Contract #: 04-0120F4Cty: SF/ALA Rte: 80 PM: 13.2/13.9File #: 69.25B**QUALITY ASSURANCE -- NON-CONFORMANCE REPORT****Location:** Changxing Island, P.R. China**Report No:** NCR-000774**Prime Contractor:** American Bridge/Fluor Enterprises, a JV**Date:** 25-Jun-2010**Submitting Contractor:** Zhenhua Port Machinery Company, Ltd (ZPMC), Changxing Island**NCR #:** ZPMC-0736**Type of problem:**

Reference Description: QA discovered three rejectable UT indications inside areas already inspected and accepted by QC.

Subject: NCR No. ZPMC-0736

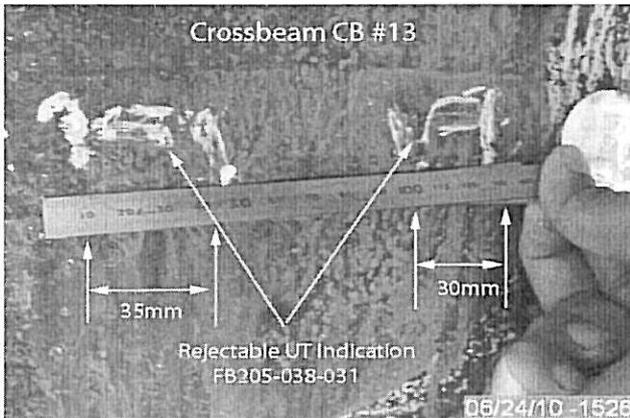
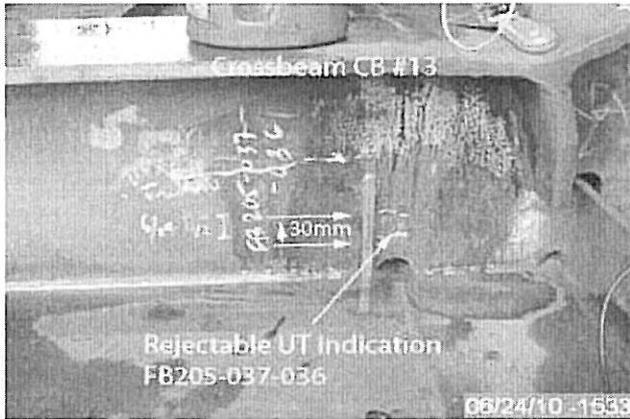
-Two of these indications were discovered in the Complete Joint Penetration (CJP) weld identified as FB205-038-031.

-The indications found in weld joint FB205-038-031 were measured to be 35mm and 30mm located at depths of approximately 8mm and 9mm with decibel ratings of +1dB and +7dB respectively.

-The third indication was discovered in the CJP weld identified as FB205-0387-036.

-The indication found in weld joint FB205-037-036 was measured to have a length of 30mm located at a depth of approximately 6mm with a decibel rating of +6dB.

-These indications are clearly marked on or near the weld.

WELD NUMBER: FB205-037-036

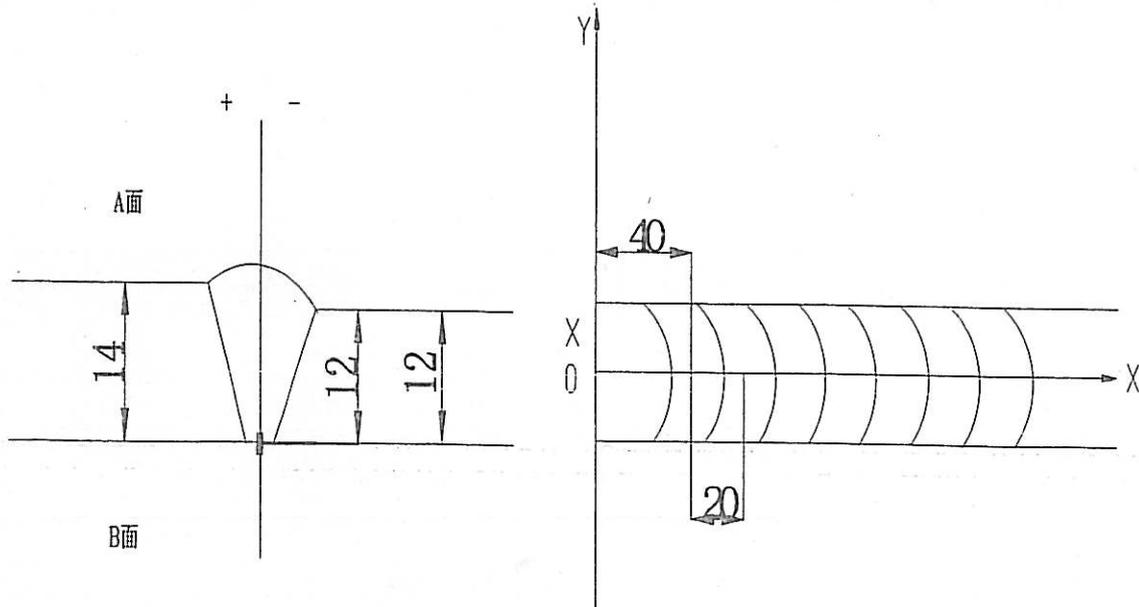
Rejected indication found by ultrasonic inspection is less than the maximum allowance aggregate length.

(UT探伤发现的缺陷总长度小于最大允许长度。) FB205-037-036

1. Did not clear the weld pass completely in time.

1. Gouge or grind from nearer side from metal edge ($D \leq 0.65T$, "D" is depth of defects, "T" is thickness of metal) to remove all defects;

2. Follow repair WPS for joint preparation, preheat, and weld deposit;

3. Verify with VT no defects remain in the weld joint prior to welding;

4. Grind the repaired area flush with base metal or the adjacent weld;

5. Check the welds according to the working drawings.

1. Improve monitoring of welding and interpass cleaning.

WELD NUMBER: FB205-038-031

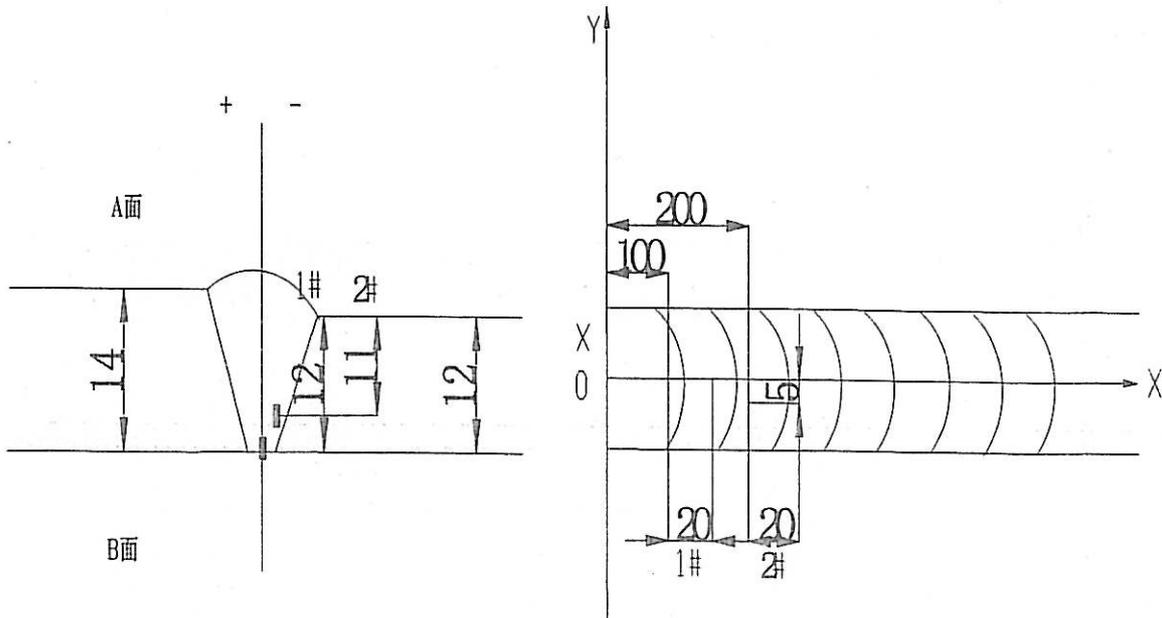
Rejected indication found by ultrasonic inspection is less than the maximum allowance aggregate length.

(UT探伤发现的缺陷总长度小于最大允许长度。) FB205-038-031

1. Did not clear the weld pass completely in time.

1. Gouge or grind from nearer side from metal edge ($D \leq 0.65T$, "D" is depth of defects, "T" is thickness of metal) to remove all defects;
2. Follow repair WPS for joint preparation, preheat, and weld deposit;
3. Verify with VT no defects remain in the weld joint prior to welding;
4. Grind the repaired area flush with base metal or the adjacent weld;
5. Check the welds according to the working drawings.

1. Improve monitoring of welding and interpass cleaning.
